Addendum No. 2 to IFB 18-24

To: All Parties on Record with the City of Somerville as Holding IFB 18-24, **Somerville Avenue Utility and Streetscape Improvements**

Re: Extend Bid Submission Deadline, Answer Questions during Q/A Period, Clarify Qualifications Requirements, Revise Unit Price Form, Revise Technical Specifications, Append List of Bid Holders

Addendum No. 2

ATTACHMENT L –
EVERSOURCE PLAN FOR NEW SOMERVILLE AVENUE DUCTBANK

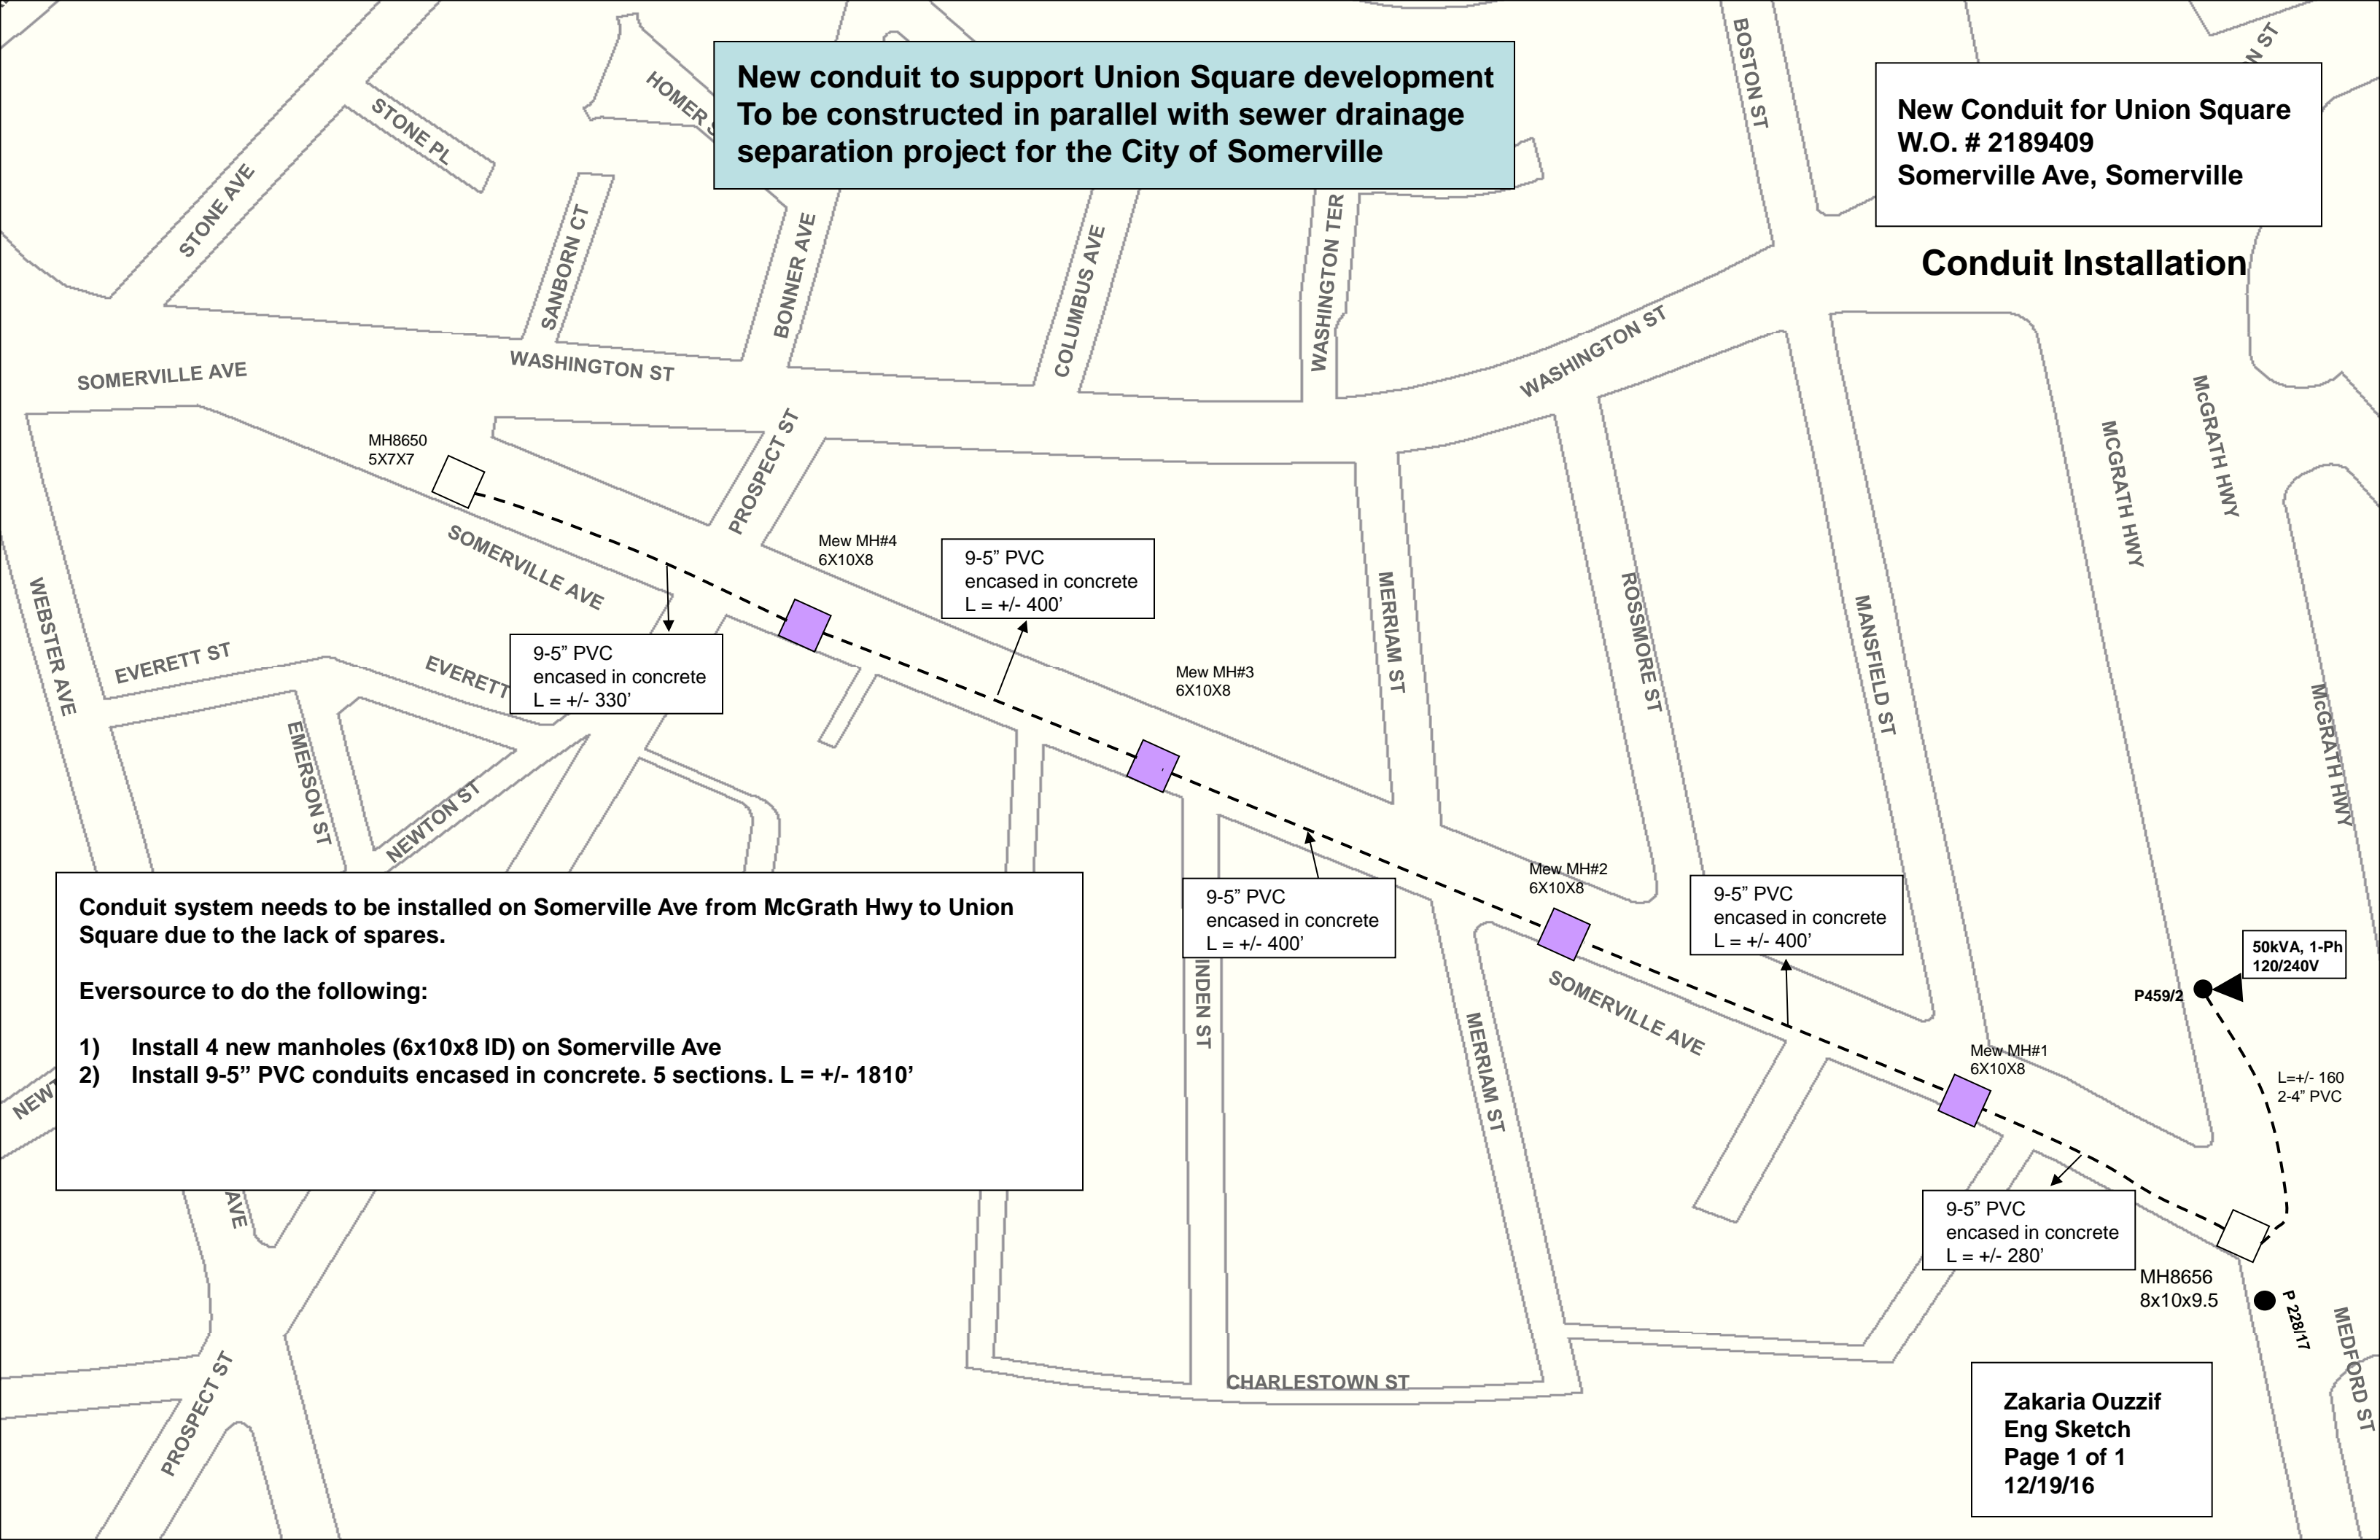
- A8: Please refer to Addendum No. 2, Item 22, which includes the current conceptual plan provided by Eversource to the City. Eversource has not yet filed with the City for a Grant of Location for this proposed ductbank, nor has Eversource developed engineered drawings. The City has controlling rights to the roadway, so Project activities will take precedence over third-party activities.

22. **Technical Specifications – Attachment L**
ADD new Attachment L – Eversource Plan for New Somerville Avenue Ductbank, included as Attachment 3 to this Addendum No. 2.

Reference Sheet No. W-1 Date: 1/16/18

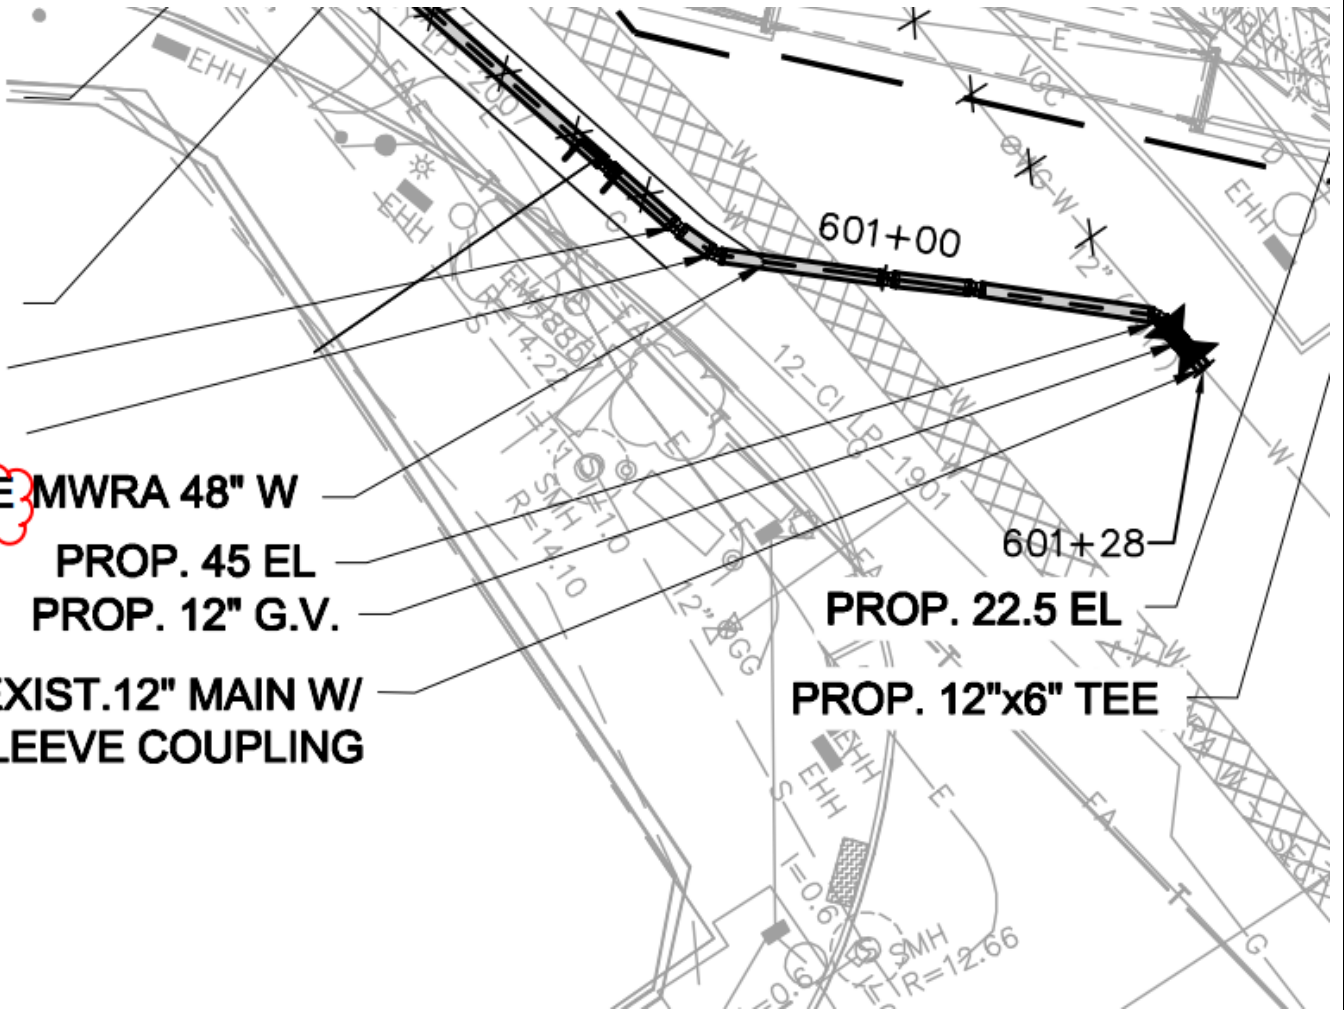
- A11: It is 4-ft. DIA w/SUMP. Please refer to Addendum No. 2, Item 29.
- Q12: Reference Sheet W-1 – water line Segment 6. The callout on this sheet says to construct the water line under the 48” MWRA water line while the profile on Sheet W-19 shows the line going over the MWRA water line. Which is correct?

23. **Drawings – Sheet W-1**
REVISE the callout for the Segment 6 water main crossing of the existing MWRA 48” main to indicate the new line shall be installed above the 48” MWRA main, as indicated in SK-W-1-1, included as Attachment 4 to this Addendum No. 2.

- A12: The proposed water main shall be installed over the 48” water main and insulated when its depth of cover is less than 5 ft. as indicted on Sheet W-19. Please refer to Addendum No. 2, Item 23, which corrects the callout on Sheet W-1.

Attachment 5 – Sketch SK-W-2-1

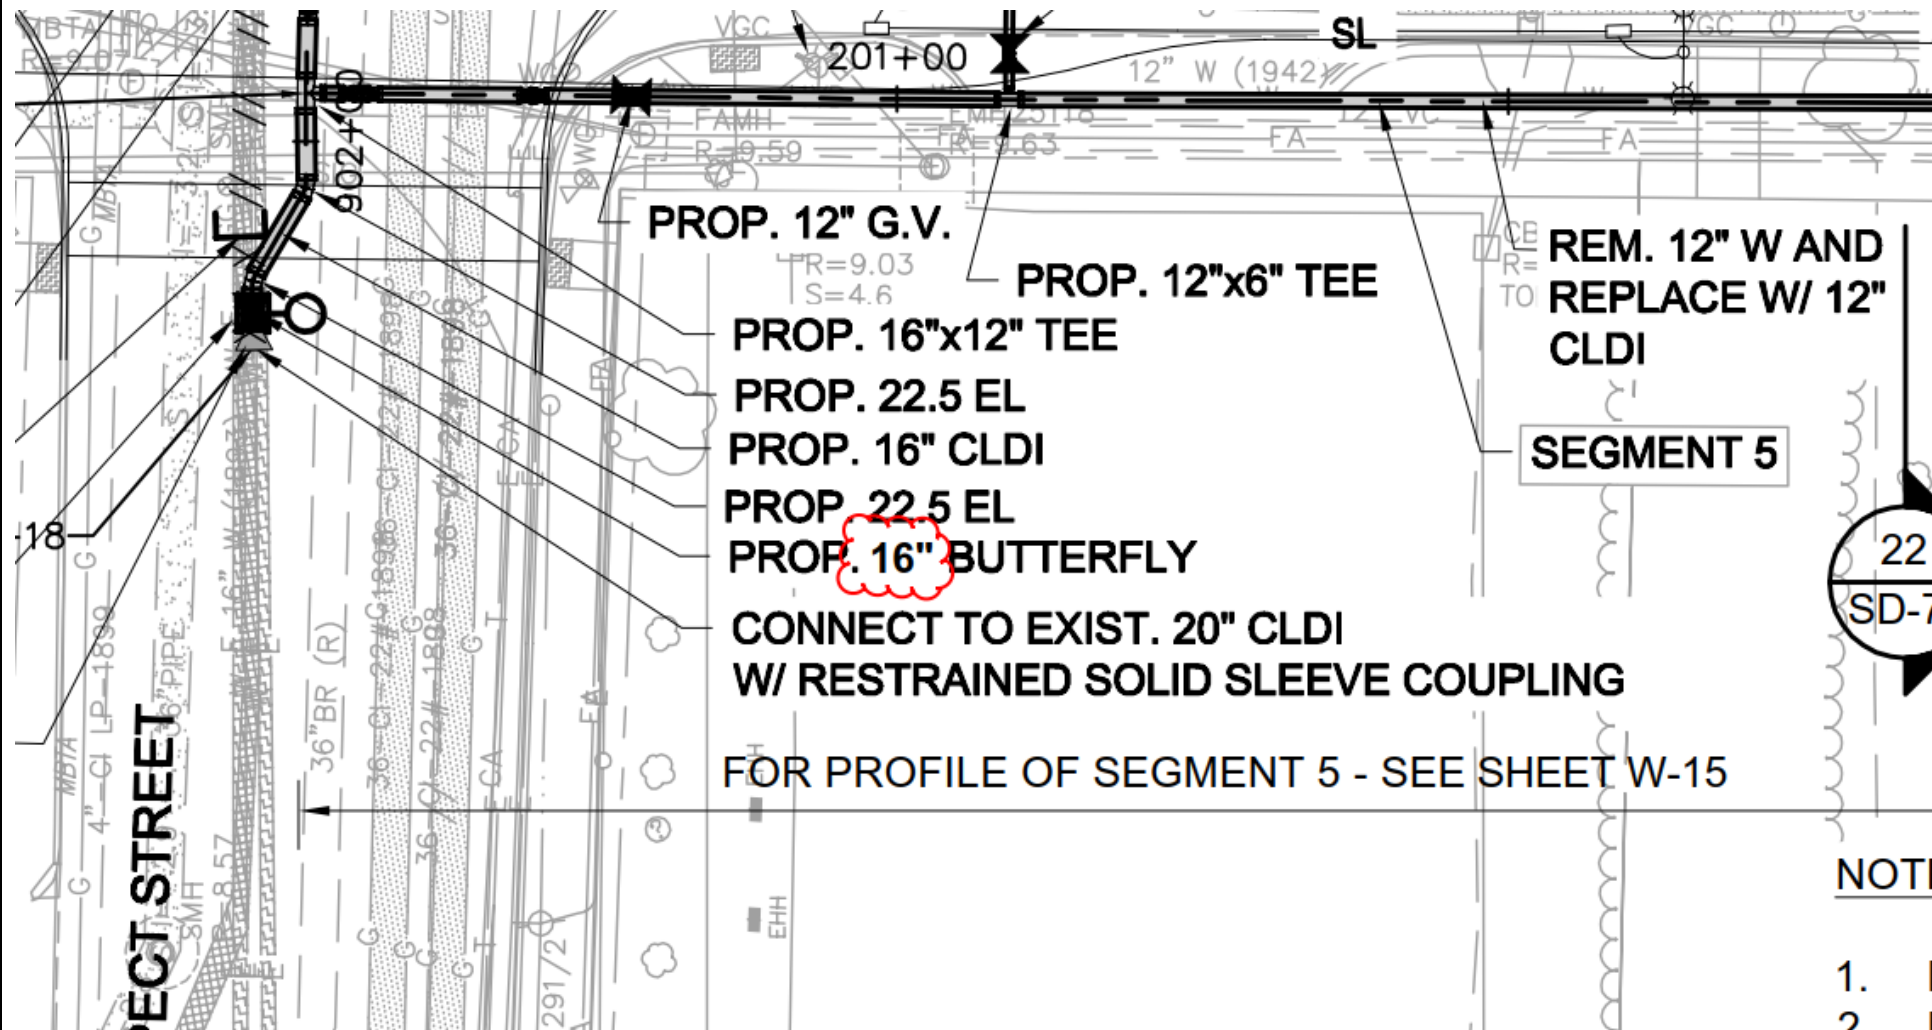
- Q4: Reference Sheet W-2, Section 3 - 16" Water Main: On the south side of Prospect @ Somerville Ave calls out a 20" Butterfly Valve while the profile on plan Sheet W-10 sheet calls for a 16" butterfly valve. Which is correct?

24. **Drawings – Sheet W-2**
REVISE the callout for the Butterfly Valve in Segment 2 south of the tee with Segment 5 to indicate the “Prop. 16” Butterfly”, as indicated in SK-W-2-1, included as Attachment 5 to this Addendum No. 2.

- A4: This should be a 16-inch butterfly valve as it is after the proposed 16"x20" Increaser at Prospect Street. Please refer to Addendum No. 2, Item 24.

Attachment 7 – Sketches SK-SD-4-1 and SK-SD-4-2

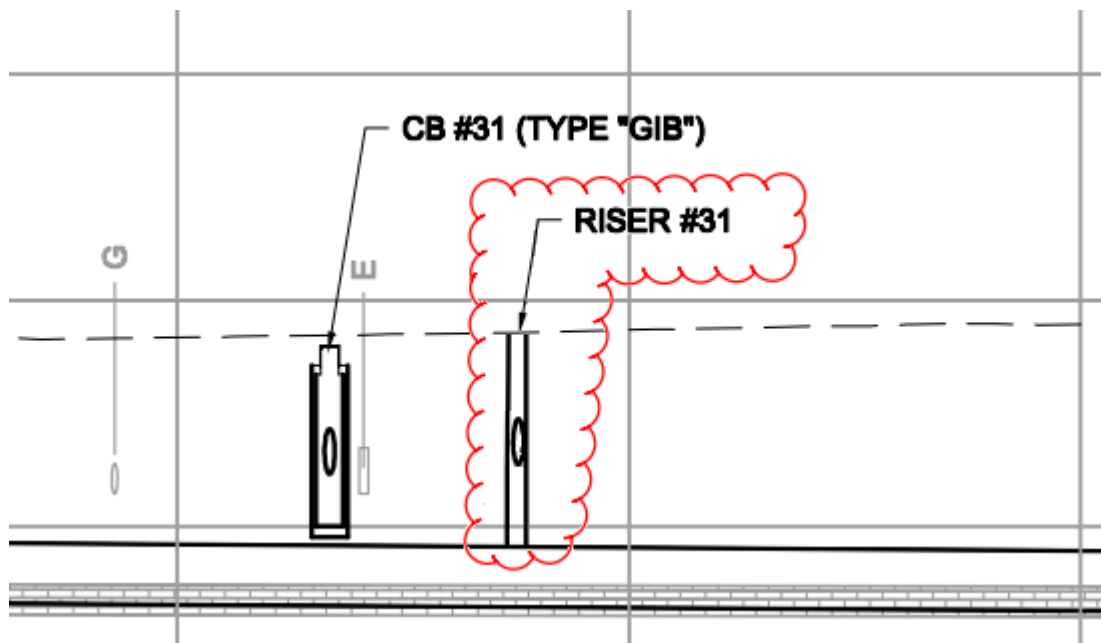
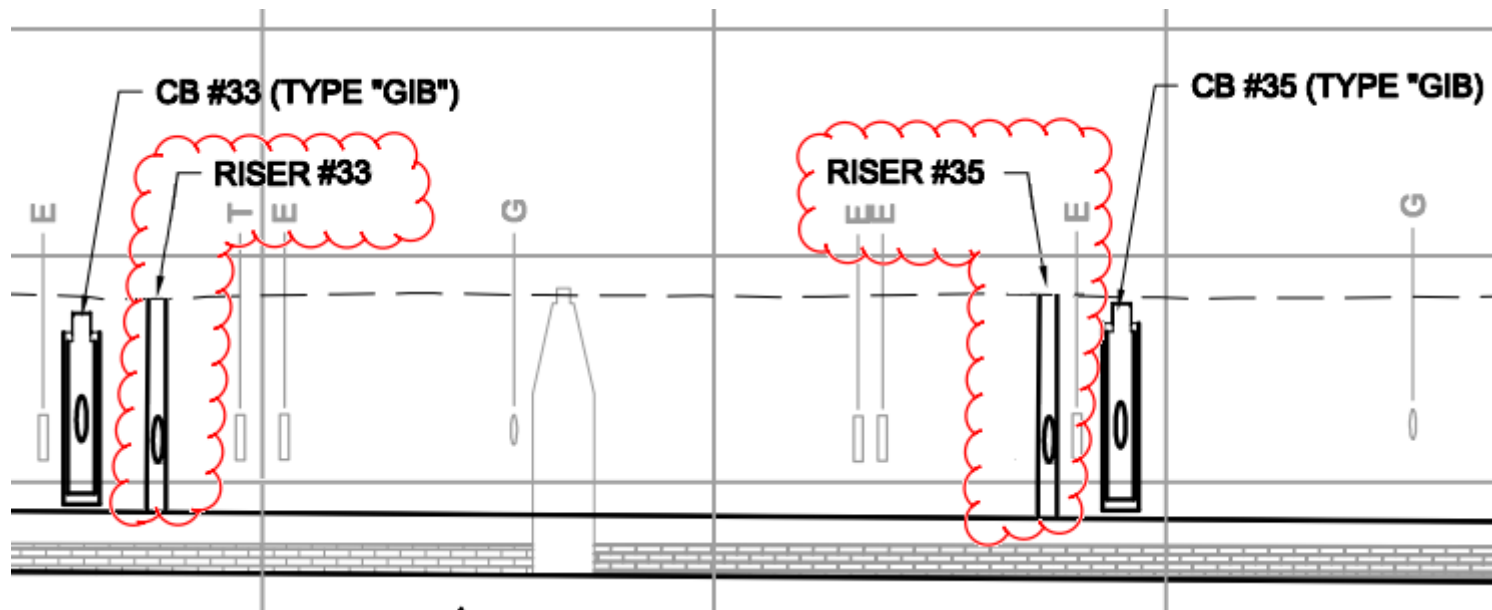
Note: In the Eversource filing for its Grant of Location, Eversource did not include this ductbank run.
28. **Drawings – Sheet SD-4**
ADD Risers #31, #33, and #35 to the Profile, as indicated in SK-SD-4-1 and SK-SD-4-2, included as Attachment 7 to this Addendum No. 2.
29. **Drawings – Sheet SD-5**
REVISE the callout for CB#41 in the Profile, as indicated in SK-SD-5-1, included as Attachment 8 to this Addendum No. 2.

Attachment 8 – Sketch SK-SD-5-1

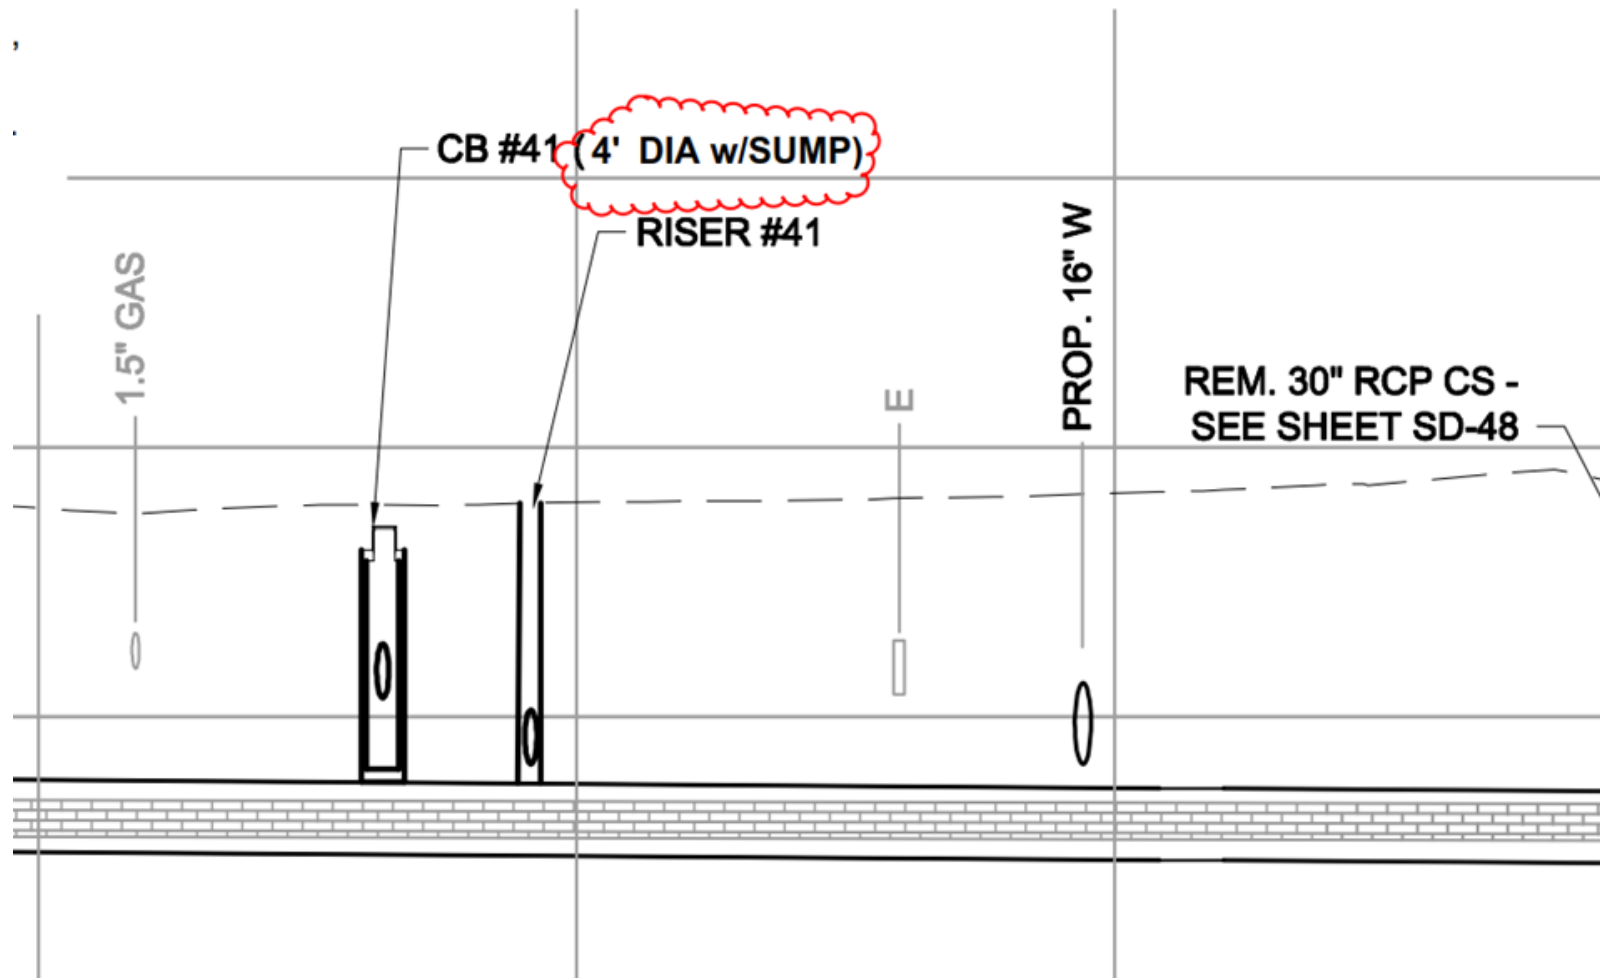
- A10: Yes, the structure is included in this Project. Please refer to Addendum No. 2, Item 30 for rim and invert information.
- Q11: Catch Basin CB #41 is shown on the profile on sheet SD-5 as a type SB structure. It is listed in the table on sheet SD-67 as a 4-ft. DIA w/SUMP. Which is correct?
